TECH BULLETIN 128

Product changes to crankcase, bearing covers, and shaft protector for all 15 and 18 Frame plunger pumps

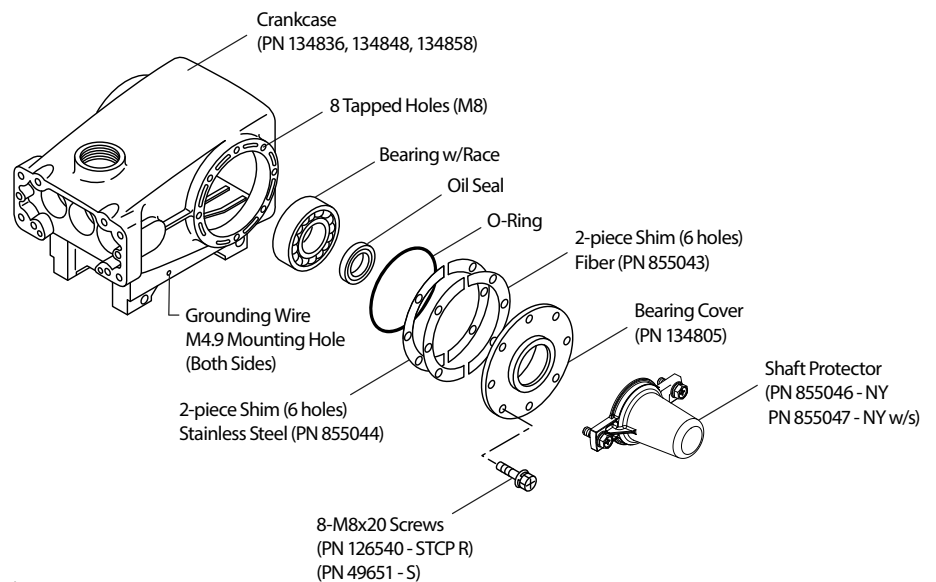
Changes have been made to the crankcase and mounting hardware to better support the weight of direct drive bell housings. This affects all 15 and 18 frame plunger pumps with date codes/serial numbers after April 2019. (See reverse side for specific models)

New Crankcase Style

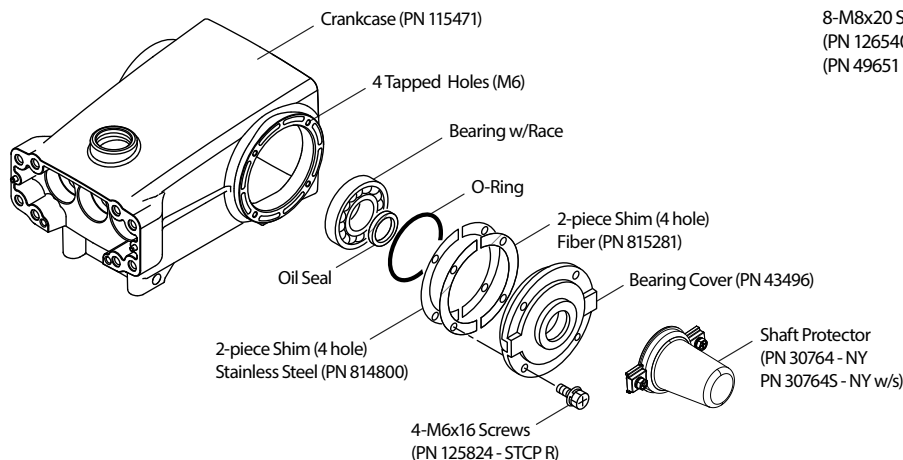
- Crankcase bell housing mounting bolt holes number increased from four (4) to eight (8) to better distribute weight of motor on crankcase.
- Bell housing mounting bolt quantity and sizes changed from four (4) M6 to eight (8) M8 bolts.
- Un-tapped M4.9 - sized grounding wire mounting holes have been added on both sides of the crankcase.
- M4.9 I.D. hole (both sides) can be tapped to a M6 thread.

- Bearing cover bolt holes enlarged (Four [4] x M9) to accommodate M8 bolt size.
- Shaft protector bolt holes enlarged (Two [2] x M9) to accommodate M8 bolt size.
